TO: CITY MANAGER 2003 APRIL 8

SUBJECT: REZONING REFERENCE #63/97
Residential and Commercial Mixed-use Redevelopment
of the Middlegate Shopping Centre

PURPOSE: To respond to points raised at the 2003 January 28 Public Hearing for Rezoning Reference #63/97

SKETCH # 1

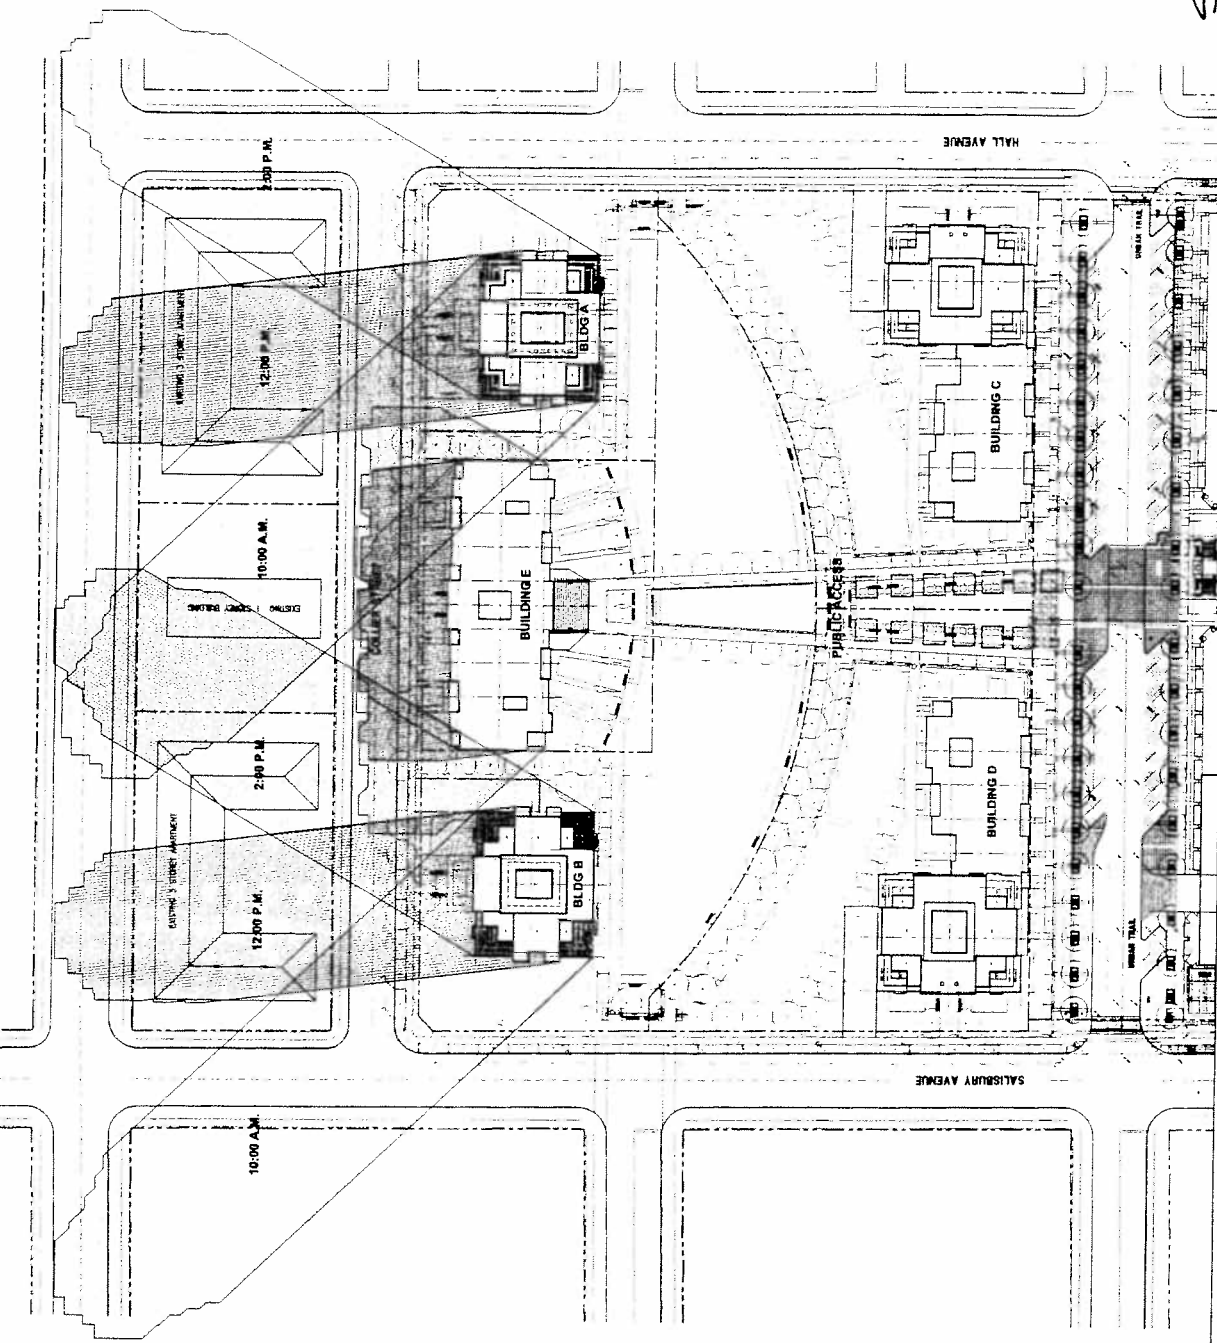
The owners of the low-rise apartment buildings north of Collier Street expressed concerns regarding potential shading by the two proposed 27-storey apartment towers on Collier Street, and asked whether they could be moved back further from the street. In response, the project architect has moved the proposed apartment buildings approximately 4.6m (15 ft.) further south from Collier Street, increasing the setback from the previous 6m (20 ft.) to 10.7m (35 ft.) from the property line.

The architect has also provided the **attached** Sketches #1 and #2 showing the shadows created by the two new apartment towers between 10 a.m. and 2 p.m. at the spring and autumn equinoxes (the standard for measuring sun shading) and at the summer solstice. These sketches show that portions of the buildings on the north side of Collier will be affected by shadows for a short period of time at the equinoxes, but that there will be no shading impact at mid-summer. It is important to note that the proposed point block towers cast slender shadows which move across the face of the buildings to the north affecting only portions of them at any given time.
